Memorandum

RE: Glade Spring Crossing Engineering Responses

Please accept this memorandum as responses from the applicant of Glade Spring Crossing to staff and neighborhood comments received in the staff reports and via email in the last few weeks.

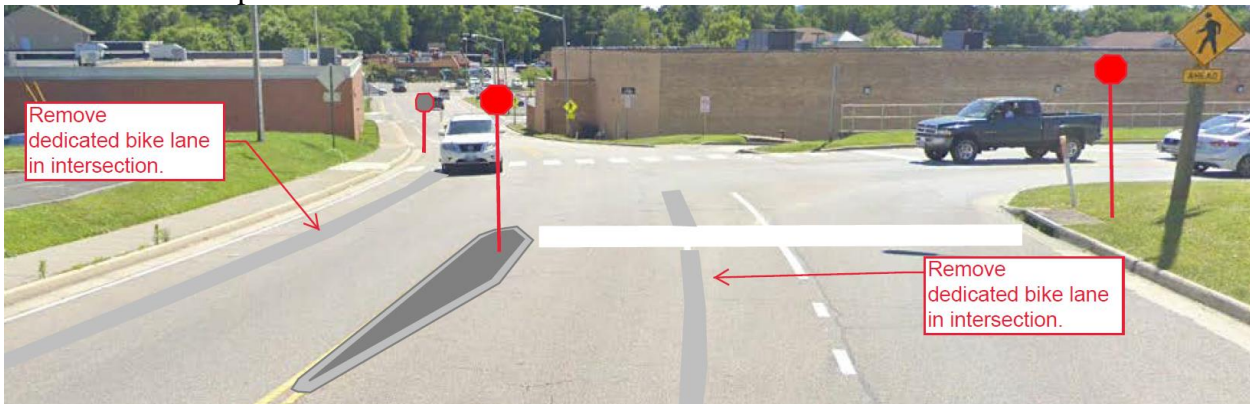
1. **Request of applicant for further study regarding Glade/Old Glade intersection and a 3-way stop.** A summary below is provided and costs attached.

Placement of stop signs should meet the regulations specified in the Manual on Uniform Traffic Control Devices (MUTCD), specifically Part 2A and 2B. The lateral offset from edge of traffic to edge of sign shall be at least 2' (lateral offset). A 6' lateral offset is preferred. With the retrofit to current conditions, the 2' lateral offset will be difficult and may require bicycle lane adjustments or sidewalk adjustments.

1. In the westbound direction, create an island in the existing bicycle lane to place a stop sign and stop bar.
2. In the eastbound direction, create an island to separate thru lanes and place two stop signs and associated stop bar.
3. Provide an advance warning sign at the Citgo Deli Mart to address visibility and potential traffic queues.
4. Without additional parameters outlined, a working budget of \$50,000 to \$65,000 should be utilized to place concrete islands for sign posts, modify the existing dedicated bicycle lane, provide adequate traffic control measures during construction. The work scope is small in nature leading to higher unit costs.
5. These measures do not address any existing pedestrian crossing problems such as lack of landing along Old Glade Road.

Potential image in the westbound direction.

Visibility concerns in the eastbound direction.

Recommended improvements in the eastbound direction.

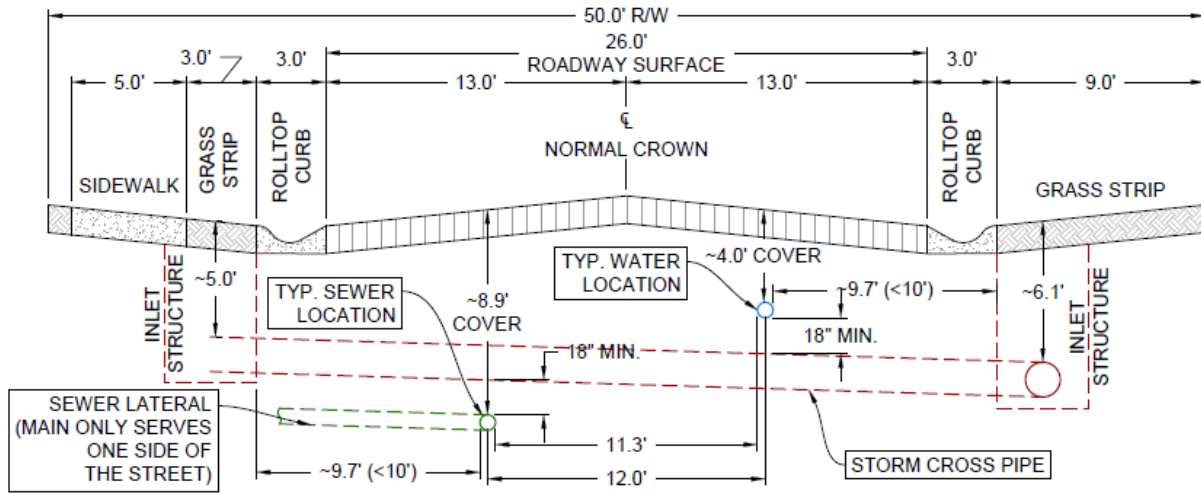
a. A potential wetland at the old Farm Pond was not originally shown contiguous to the Creek Valley overlay and was not included in its limits because the engineer determined that it was separated by an embankment and did not touch the 50’ required buffer line within the CVO. Further, the wetland is preliminary and the location and validation of it cannot be determined until approved by USACE in the preliminary plat stage. At this time they are located as flagged by the applicant’s environmental consultant. If the old Farm pond wetland area is determined to be a wetland, it will be mitigated with the USACE in the permitting process. The developer will likely have to purchase wetland bank credits in order to mitigate the wetlands prior to building a new stormwater management wet pond facility. The wet pond will provide a much larger, more prosperous and beneficial wetland than the farm pond currently offers. The resulting new BMP would provide regional water quality benefits much larger than that of the farm pond.

b. In discussion, staff prefers the wetland be shown as contiguous to the Creek Valley overlay as it is contained in “backwater” from the 100-year floodplain elevations. While the applicant agrees that the wetland is contiguous to the backwater, the creek valley overlay ordinance wording does not support this methodology and should likely be examined if this is the way the Town plans to enforce it. Regardless, the applicant has agreed to show the wetland contiguous to the CVO. This has been updated in the application mapping and in the calculations where it originally resided.

c. The result of showing this contiguous to the creek valley overlay, is that permission must now be sought to disturb within the CVO. The stormwater quality wet pond embankment must be located within the CVO in order to be installed. The footprint of the new Wet Pond is fixed in order to provide the required DEQ settling and pond areas that promote pollutant reduction. The upstream water quantity storm management facility and road crossing also squeeze the wet pond into the position as shown. The CVO disturbance request has been made to the Zoning Administrator under a separate memorandum. If the request is unable to be approved, the project will be unable to achieve on-site water quality and credits will likely have to be purchased. Furthermore, the project will be unable to provide regional pollutant reduction above that required for the project.
